### **Independent Geotechnical Expert Review Panel 2008 Reports**

**Re: Meadowbank Dike Review Board (MDRB)**  
**Report No. 1**

**Re: Meadowbank Dike Review Board (MDRB)**  
**Trip Report – Dr. Andrew M Robertson – October 31, 2008**

Photo 1 – East Dike crest with Primary holes grouted in casings protruding

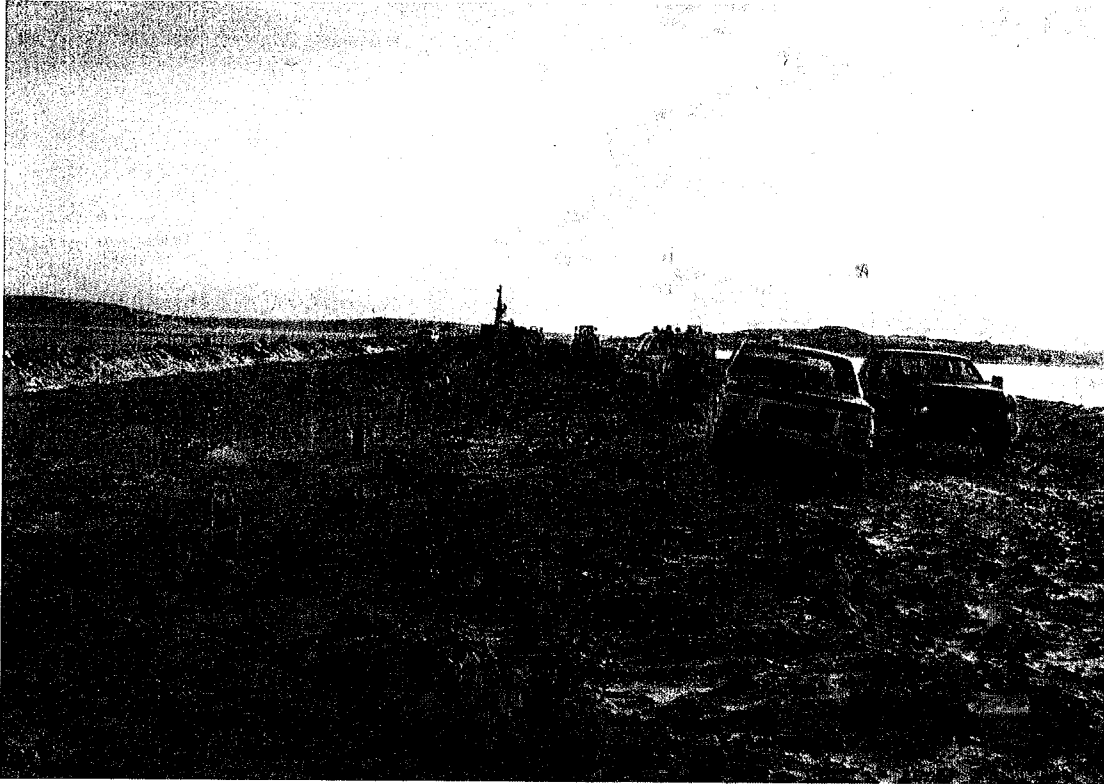
**October 31:** Travel from Baker Lake to mine site. During the morning Mr Gaston Blanchette presented a review of the overall project dike requirements, investigations, designs and design changes, and construction progress. In the afternoon the East Dike was inspected (Photo 1) including the grouting installations and partially excavated trial grout area (Photos 2 to 4 and 7), and returned to Baker Lake. In the evening Gaston Blanchette completed the review presentation of the materials submitted for MDRB review during Meeting No 1.

Photo 3 – Grout bulb with excavated ungrouted 'crush' fill adjacent

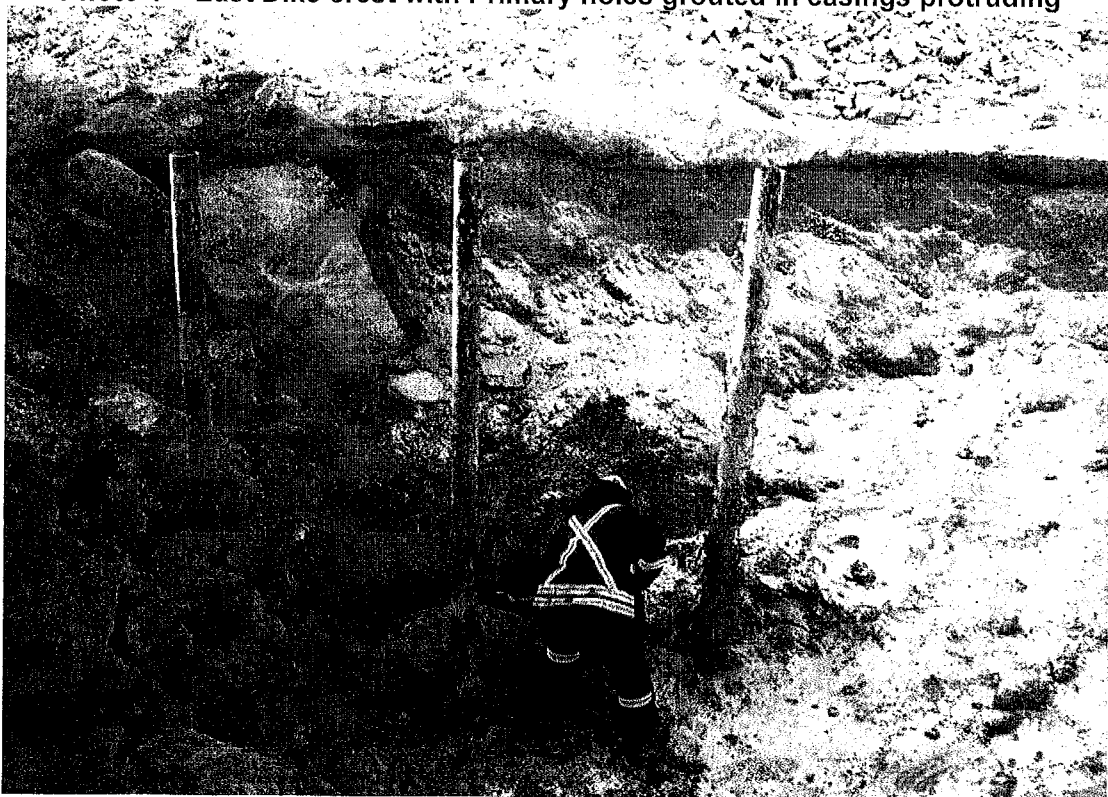
The grouting trial excavation indicated the presence of loose ungrouted 'crush' fill at the base of the cutoff wall fill material. This is apparent in the deeper 'hole' excavation seen in Photo 3. The grout bulb achieved by the GIC grouting trial clearly indicates the presence of open matrix crush prior to grouting. Reliable grouting of the toe of the cutoff wall is a necessity to prevent rapid seepage through such crush fill. Grouting of the rock below the upper surface could not be inspected.

The grouted bulb produced by cement grout intrusion from the GIC trial showed effective penetration of grout into the crush but for a limited distance (about 35 cm for the bulb seen in Photo 3. The conventional cement grout penetrates the crush well (see Photos 5 and 6) and the cement particle size does not appear to be a constraining factor.. It seems unlikely that the use of microfine cement will increase the radius of penetration significantly.

Photo 7 - "tube-a-manchette" (TAM) grouting tube (white) in test zone still to be excavated

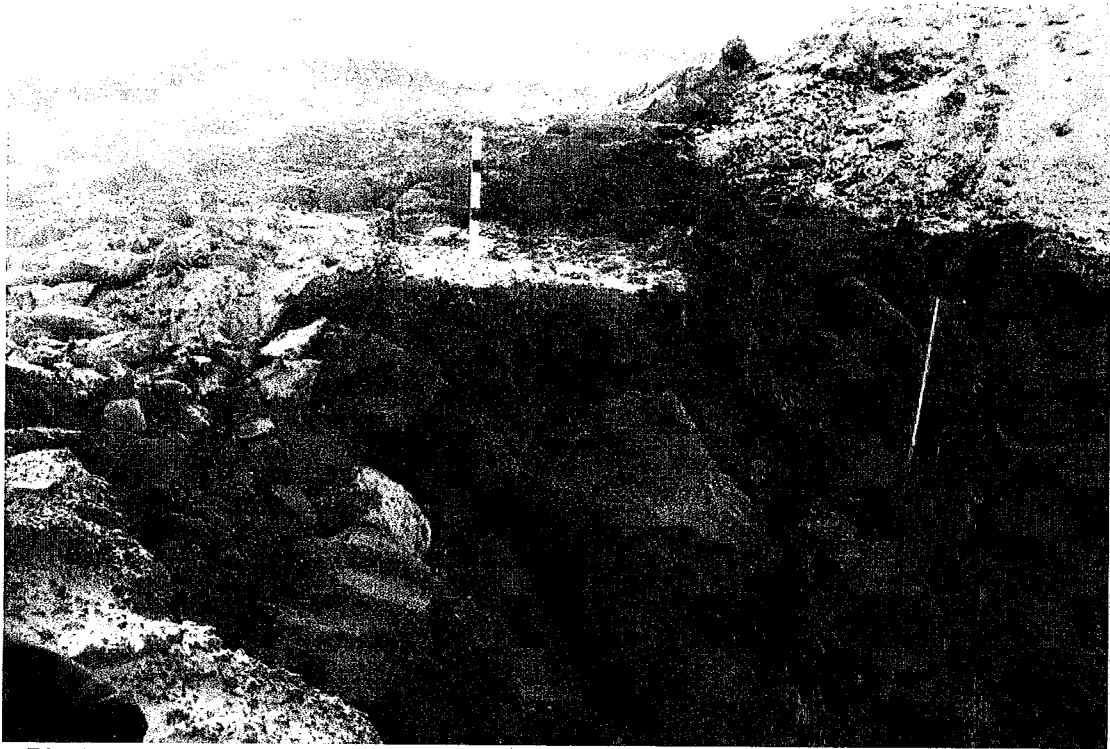
East dyke earthfill and slurry cut-off wall had been completed (Photo 7) together with installation of every second primary 'grouted in casing' in preparation for cut-off wall toe grouting. The grouting crew was off site waiting on a decision on which of two grouting procedures to implement.

A grouting test had been completed where both the 'grouted in casing' (GIC) and "tube-a-manchette" (TAM) methods had been applied at a location where excavation of the grout bulbs for inspection was possible. At the time of the visit the grout bulb for one of the GIC trials was being excavated (Photo's 2 to 4). The TAM trial for which the white grout casing is seen in Photo 7 had not been excavated.
